# Access Compliance Report

## Public Rights-of-Way

| Intersection ID: 5704                   | Main Street: W W T HARRIS BV | Cross Street: N TRYON ST                | Location: S            |
| ADA ID: B68D3312823E                    | Ramp Type: Perp              | Initial Pass/Fail: Fail                 | Overall Compliance: No |

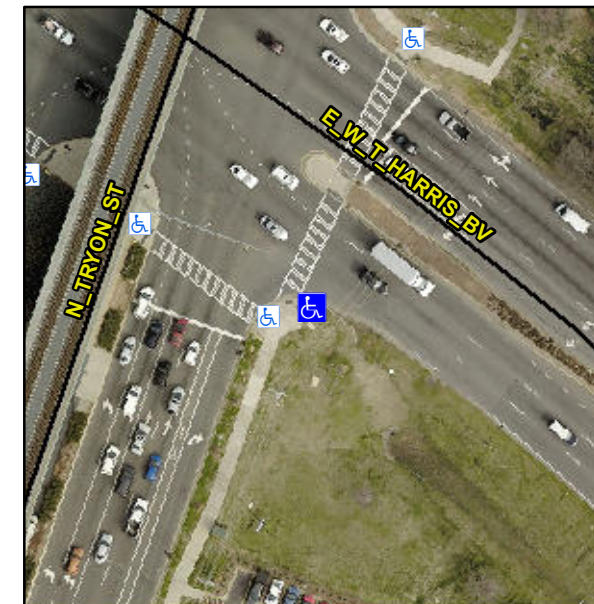
**Not Found, R304.2.2**

| Compliance | Description           | Data  | Compliance | Description                 | Data |
|------------|-----------------------|-------|------------|-----------------------------|------|
| N/A        | Ramp Length (in)      | 96.0  | No         | Ramp Slope (%)              | 9.7  |
| N/A        | Gutter Ponding?       | Yes   | N/A        | Gutter Slope (%)            | N/A  |

**Remove & Replace Entire Ramp.**
